## In the drawings:

## **REMARKS**

FIGURE 3

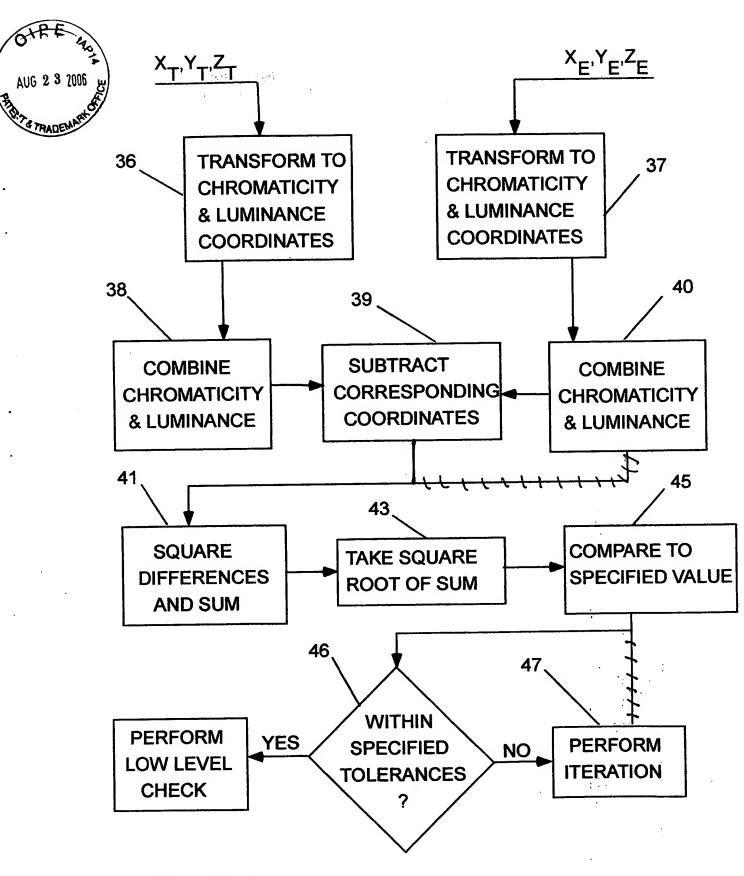
In Figure 3, delete the line extending from the block 40 labeled COMBINE CHROMATICITY & LUMINANCE to mid-way of the block 39 labeled SUBSTRACT CORRESPONDING COORDINATES and add a line extending from block 39 to new end of the line extending to block 41 labeled SQUARE DIFFERENCES AND SUM, as shown in red on the enclosed correction sheet. A replacement Figure 3 is also enclosed.

Figure 3 of the drawings has been amended to eliminate incorrect indications of action flow. Justification for these corrections may be found on page 6 lines 4 -15, where the description of the activity flow is consistent with the figure corrections.
